Narrows Inlet Hydro Project

Environmental Assessment Certificate Amendment Application #4 to EAC #E13-04

December 19, 2016

Ecofish Research Ltd.

Figure 1. Original assessment of VSU #1066 by Chartwell (2011).

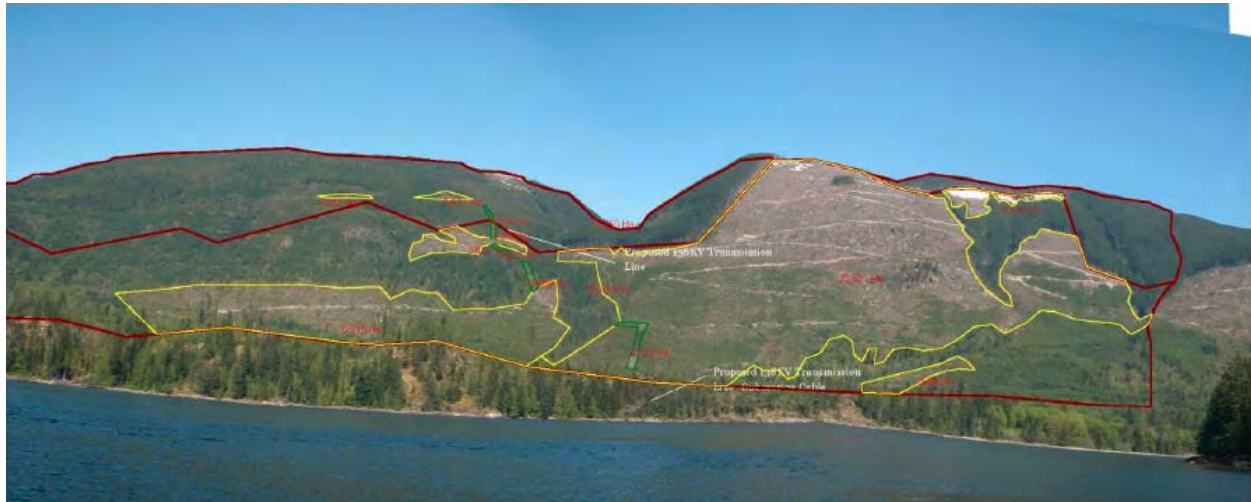
summarized these units (Chartwell 2011). VSU #1066 is categorized by the “Partial Retention” definition which indicates that the VSU assessed from a significant viewpoint is: (i) easy to see, (ii) small to medium in scale, and (iii) natural and not rectilinear or geometric in shape (Figure 1). VSU #1066, which corresponds to the private land area, contains many large disturbances and does not meet the % alteration goals for the “Partial Retention” objective (Chartwell 2011). The VQO for #1089 was categorized as having a “Retention” objective which indicates that the disturbance is: i) difficult to see, (ii) small in scale, and (iii) natural in appearance (Figure 2). The results of the baseline study concluded that the % alteration of VSU #1066 and VSU #1089 were both not within the relevant VQO guidelines. Thus, for both VSU, existing disturbance prevented the VQO guidelines from being met.

Nevertheless, assessment of the potential for the conclusions of the EA to change with the alternate alignment was conducted through a qualitative evaluation based on available information. The approved and alternate routings of the transmission line on the east side of Sechelt Inlet are modelled in Figure 3, which represents the simulated view from the Sechelt Inlet viewpoint. The highest elevation portion of the alternate alignment will run alongside an existing disturbance (i.e., logging road) at the top of the ridge and it is likely that the visual disturbance along the ridge will blend into the existing landscape and will not create any new “major lines” or unnatural bisection of the landscape. Further, the western portion of the transmission line for the alternate alignment will span the gully (central in Figure 3) to connect to this existing disturbance and will therefore not impact the mature forest in the gully or cause a visual corridor within it. The vertical descent of the alternate transmission line will produce a new visible corridor or line in the landscape. However, once this descent is complete the new alignment is routed to the north through a depression and is not visible until it emerges in a similar location as the approved alignment and runs to the shoreline. In comparison, the vertical descent of the approved alignment will traverse a forested area on the north side of the gully which is currently less disturbed than the area that will be transected by the alternate alignment (on the south side of the gully). Based on our qualitative evaluation it is therefore not expected that the visual quality of VSU #1066 will differ substantially between the approved and alternate routing considering that the alternate routing would impact an already disturbed area (Figure 4), leaving the currently forested corridor on the north side of the gully intact. The visual quality of VSU #1089 will also not differ between alignments because both ROWs transect forested habitat in a similar fashion and would therefore be equally visible. Thus, based on this qualitative assessment, and given that the existing disturbance prevented the VQO guidelines from being met, the conclusions of the EA, in which a non-significant residual effect from the Sechelt Inlet viewpoint was identified, are unlikely to change for the alternative alignment.

Figure 7. Portion of Figure 2-12 cropped from Robertson (2012f) showing the three transmission line alignment options (Options A, B, and C) at the north end of Narrows Inlet that were assessed in the original EA for the Upper Ramona Component.

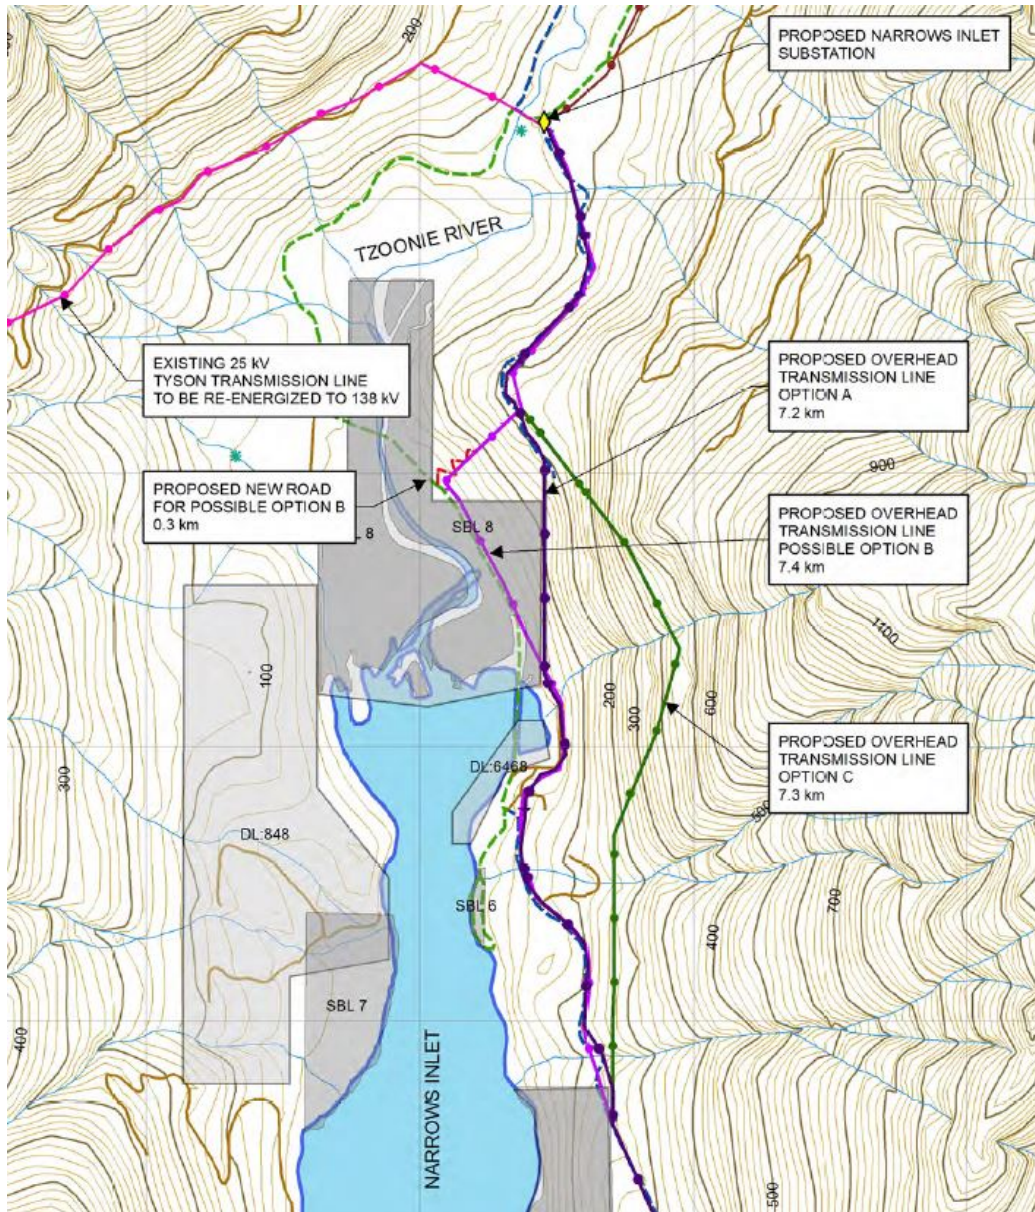
The EA assessed three transmission line options (A, B, and C) in the location where changes are proposed (Figure 7; Robertson 2012f, Figure 2-12). Among these, Option A is similar to the approved alignment and Option B is similar to the newly proposed alignment. Nevertheless, there are some differences between Option B and the proposed alignment. Option B avoided the causeway and the road immediately north of the causeway, and the two alignments have a different northeast trajectory when departing the Tzoonie Mainline forest service road (FSR) and rejoining the main alignment (compare Inset 2 of Map 4 with Figure 7). Thus, only the central portion of the proposed alignment along the Tzoonie Mainline FSR was assessed in the EA.

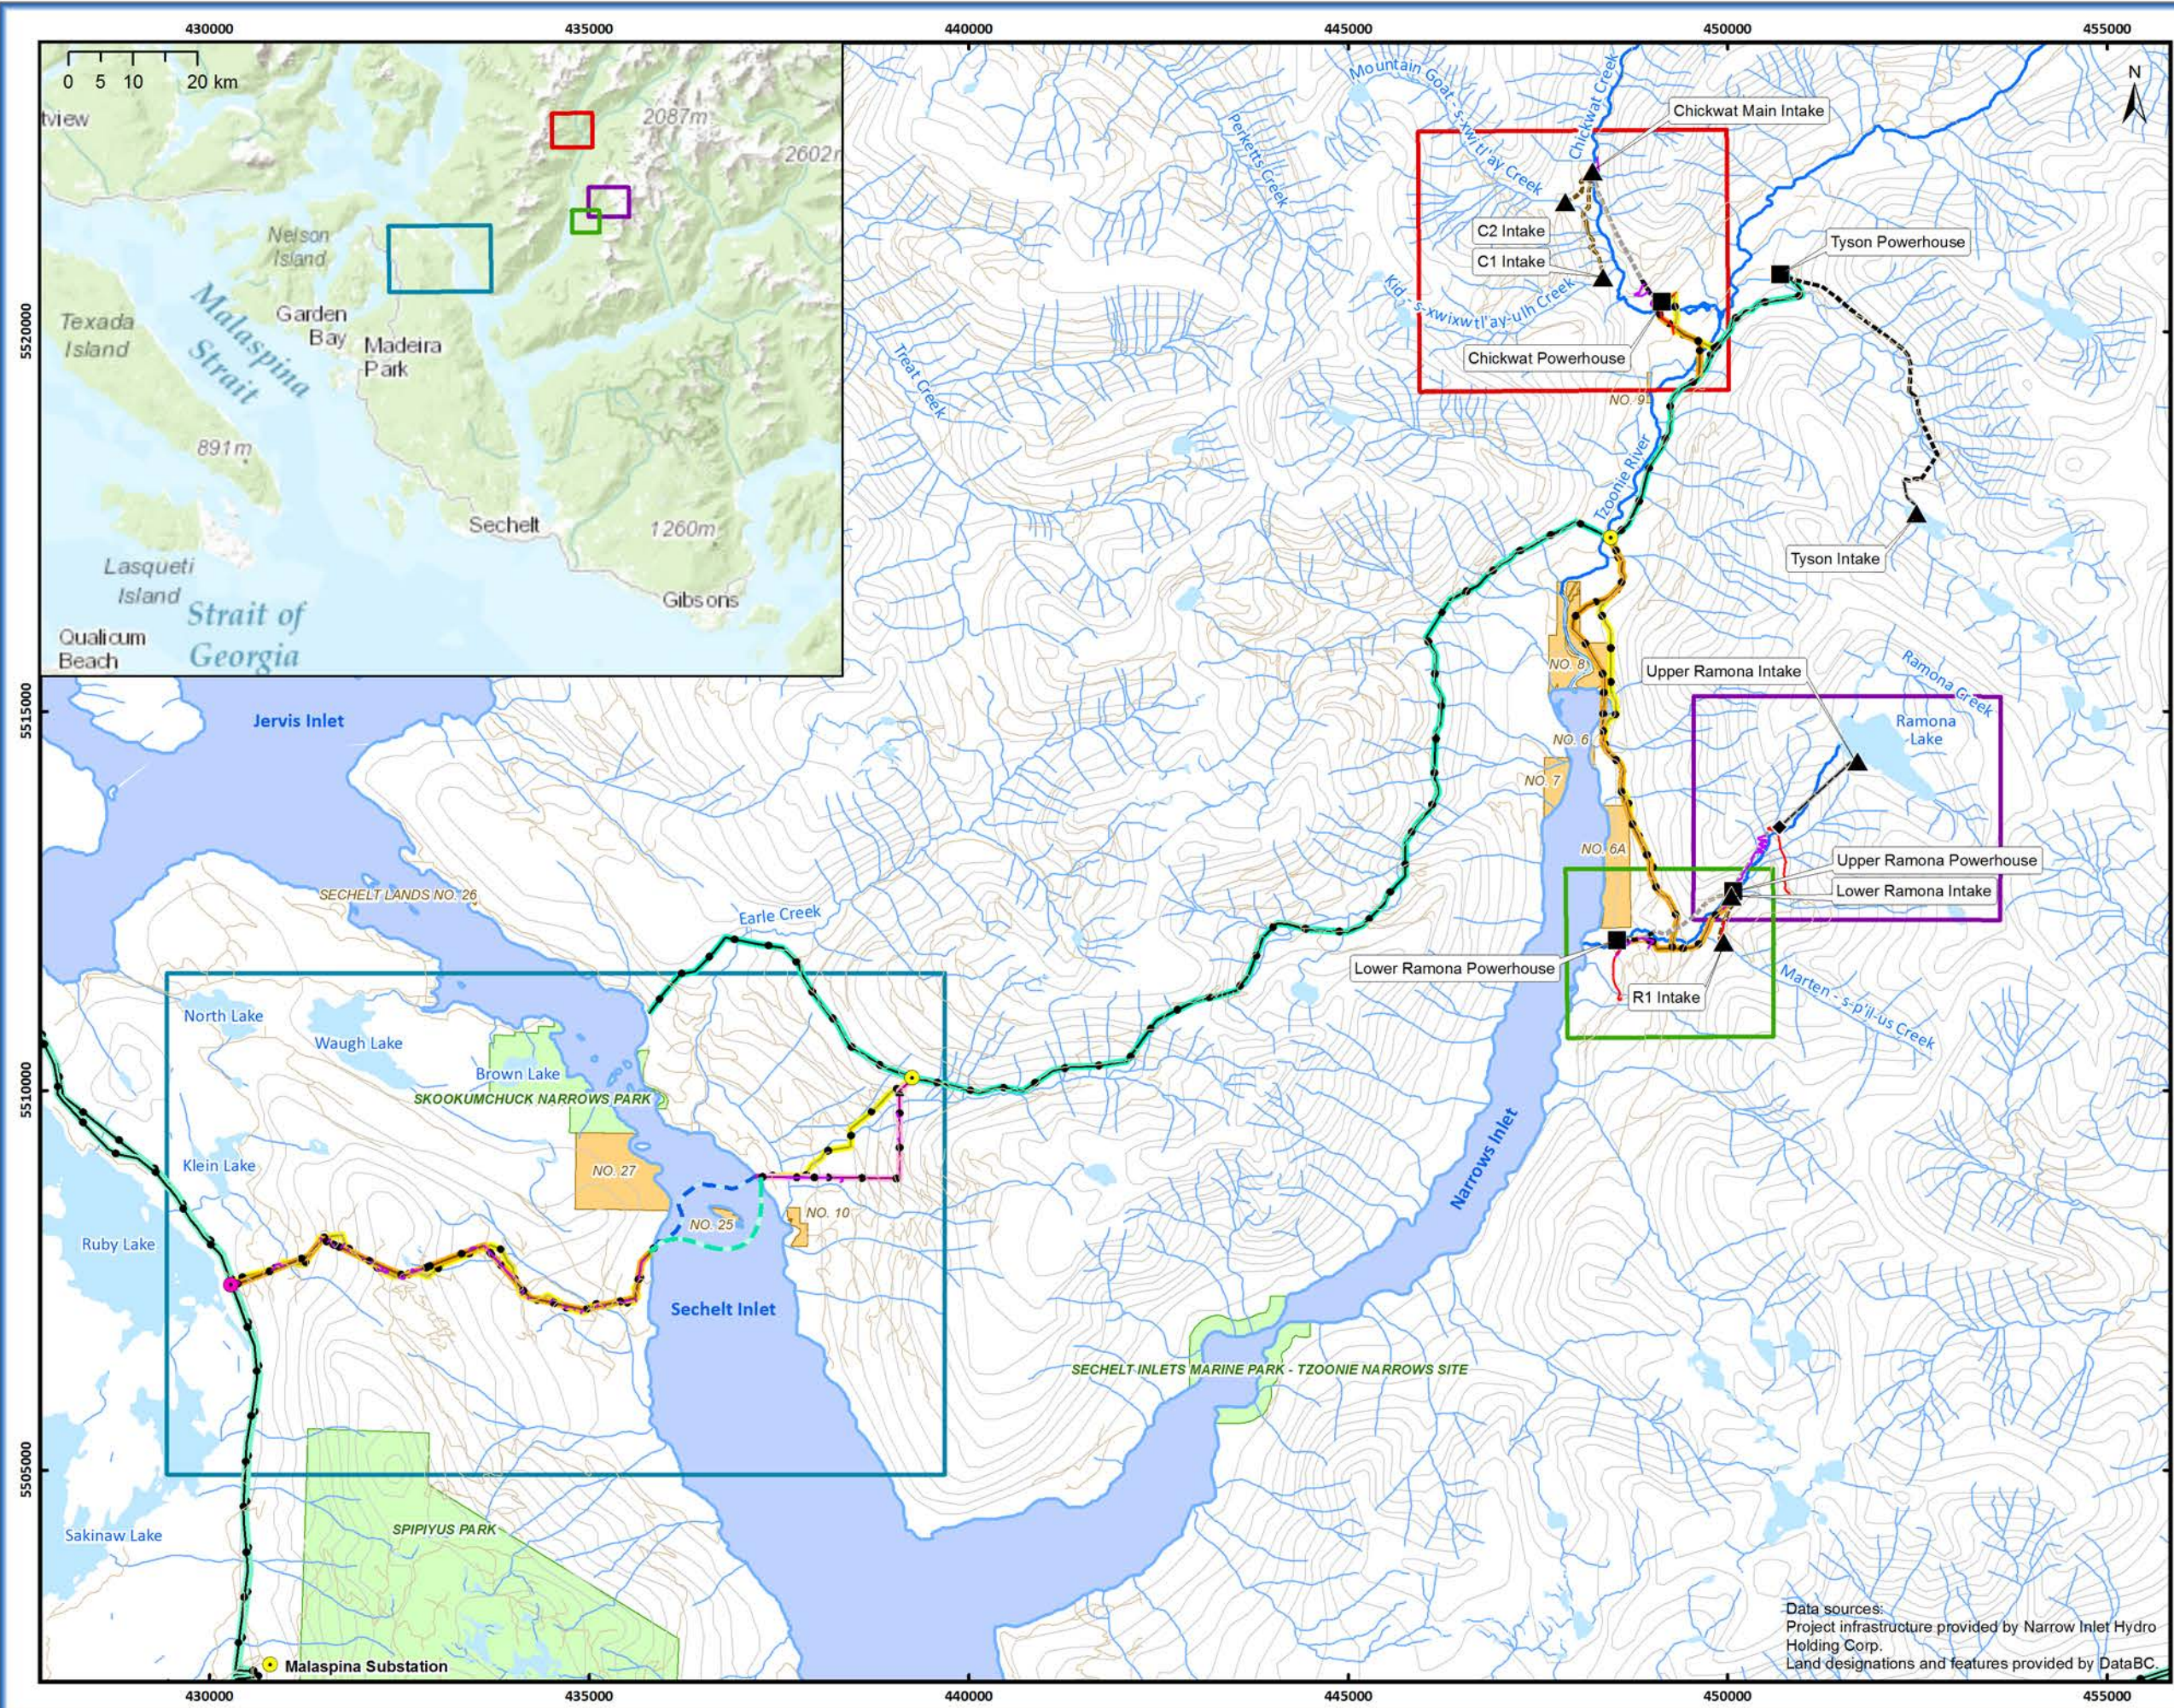
A total of five modifications are proposed for the 138 kV transmission line of the Substation and Transmission Component which would require changes to the CPD due to incursions of the 100 m infrastructure leeway and/or changes to the Project Boundary. Three of these changes are located on the west side of Sechelt Inlet, one is located on the east side of Sechelt Inlet, and the fifth is the crossing of Sechelt Inlet (Table 3, Map 3).

The three modifications in the transmission line alignment west of Sechelt Inlet (three insets on Map 3) are minor changes that would serve to straighten and shorten the transmission line. These three sections that are outside of the 100 m infrastructure leeway permitted by the CPD are 0.4 to 0.19 km in length and they extend outside of the leeway by a maximum of approximately 40 m. These modifications in alignment would have no effect on the approved Project Boundary.

On the east side of Sechelt Inlet the final alignment of the transmission line has not yet been determined because there are still private property issues to resolve. The current approved alignment on the east side of Sechelt Inlet bisects private property owned by Solberg Hills Estates Ltd., with the subsurface rights owned by Lafarge Canada Inc. Both landowners have requested that the alignment be routed to the edge of the property, as the approved alignment may be incompatible with future development (Obee pers. comm. 2016). In response, the EAC Holder is seeking an

An additional request for the transmission line on the east side of Sechelt Inlet is that flexibility is incorporated into the location of the eastern entry point of the submarine cable. This flexibility is required to provide the cable providers with greater entry options which will allow selection of appropriate (predominantly bedrock) substrate. Incorporation of this flexibility into the CPD requires that the infrastructure leeway is increased for the westernmost approximately 300 m of the transmission line and the eastern cable entry point (shown as a grey polygon in Map 3 within which this infrastructure must be located).

The preferred alignment for the submarine cable that crosses Sechelt Inlet also has not yet been finalized. The approved alignment of the submarine cable takes a rounded path north around Skookum (Boulder) Island (Map 3), located in the centre of Sechelt Inlet. Analyses to date have suggested that a preferred route for the submarine cable is to cross the inlet south of Skookum Island. This modification in alignment may be desired because there is reduced current flow in this area (10 knots compared to 25 knots west of Skookum Island) which would almost double cable longevity, as well as improve cable laying safety and logistics (Obee pers. comm. 2016). However, because the decision regarding the preferred alignment has not been finalized, it is requested that this southern route is added as an alternative option, rather than a modified alignment. For this alternative alignment, a 1.76 km section incurs outside the approved 100 m infrastructure leeway and a 0.97 km section incurs outside the approved Project Boundary. This assessment therefore specifically considers whether conclusions of the original EA would be affected if the alignment is changed to the alternative option. If the alternative alignment is approved, both options would be authorized in the CPD. In addition, although the approximate locations of both cable alignments are known, the exact position of the cable cannot be determined until the detailed design phase when it can be finalized by the cable supplier and installer. Some flexibility in Project design and submarine cable alignment is therefore required. As such, it is requested that the two potential cable alignment options (Map 3) are not associated with the typically 100 m infrastructure leeway but that flexibility will instead be provided through a wider “cable corridor”, which coincides with the Project Boundary, within which the cable will be deployed and installed. This cable corridor has been considered in this assessment. The installation and deployment of submarine cables are considered standard activity in which case a DFO review of serious harm as defined by the *Fisheries Act* (1985) is
